Name of Dam: Dry Run No. 102
Location: Page County, State of Virginia
Inventory Number: VA 13901

PHASE I INSPECTION REPORT
NATIONAL DAM SAFETY PROGRAM

Dry Run Number 102. Inventory Number:
VA-13901. Page County, State of
Virginia. Phase I Inspection Report.

MICHAEL BAKER, JR., INC.
BEAVER, PENNSYLVANIA 15009

PHOTO 1. Eroded Vehicular Tracks on Downstream Slope

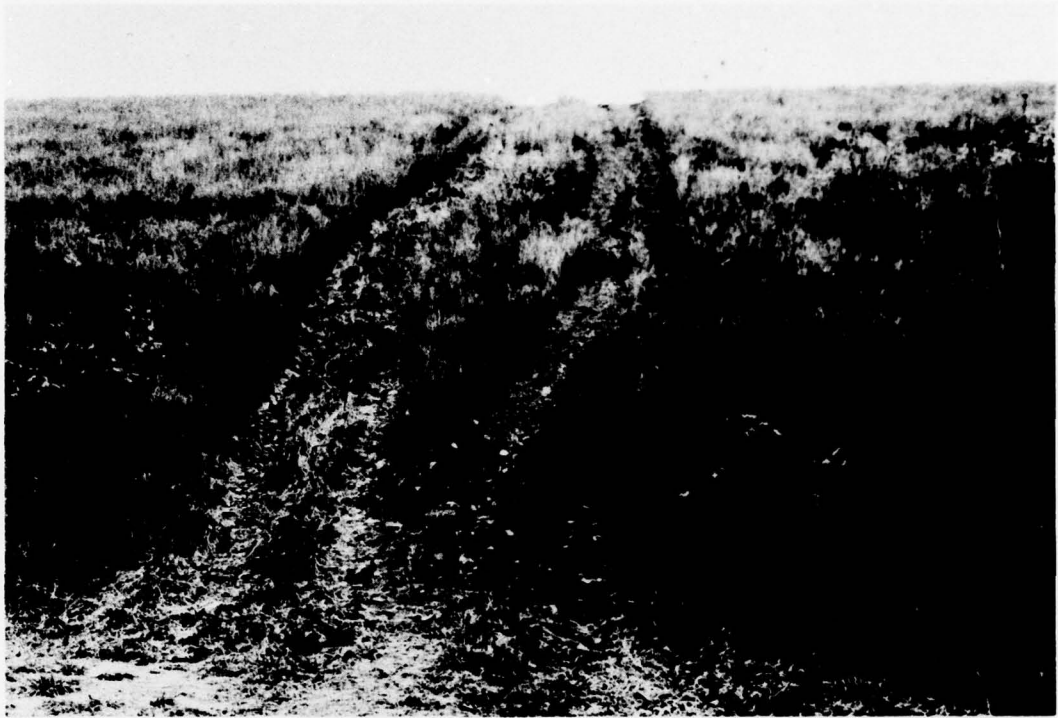
Filling and reseedling of the tire tracks on the embankment should be completed without delay to prevent erosion. Also, some means of restricting access to the embankment by vehicular traffic should be considered. If restricting vehicular traffic is not possible, a means of protecting the embankment against erosion should be implemented. Recommended remedial measures to be scheduled during the annual maintenance inspection program are to: repair bare areas on the embankment, cut all tree growth on the embankment and rock toe drains, and install a staff gage.

3.2 Evaluation: The only serious deficiency is the erosion in the tire tracks resulting from operation of vehicles on the downstream slope on the left side of the outlet works (see Photo 1). Topsoil should be placed in the bare areas and planted with grass seed. The access for vehicles should be blocked-off to prevent this problem from re-occurring. If restriction of vehicular traffic is not possible, then some means of embankment protection should be implemented.

- 7.2 Recommended Remedial Measures: The filling and reseeding of the tire tracks on the embankment should be repaired without delay to prevent erosion. Also, some means from preventing further vehicular traffic on the embankments should be considered immediately. If restricting vehicular traffic is not possible, a means of protecting the embankment against erosion should be implemented. The inspection revealed certain maintenance items listed below which should be scheduled during the annual maintenance period.

PHOTO 3. View of Riser From Upstream Face of Dam

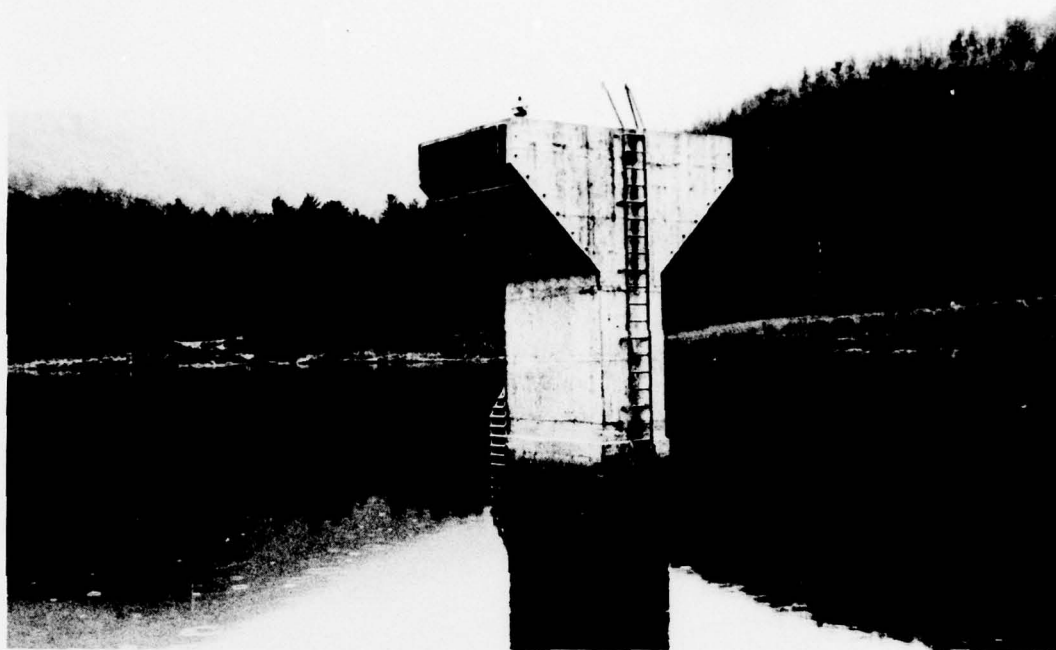
- 3.1.3 Appurtenant Structures: No structural deficiencies were observed (see Photo 3).
- 3.1.4 Reservoir Area: No serious deficiencies were observed in the reservoir. A staff gage should be installed to monitor reservoir elevations above normal pool.
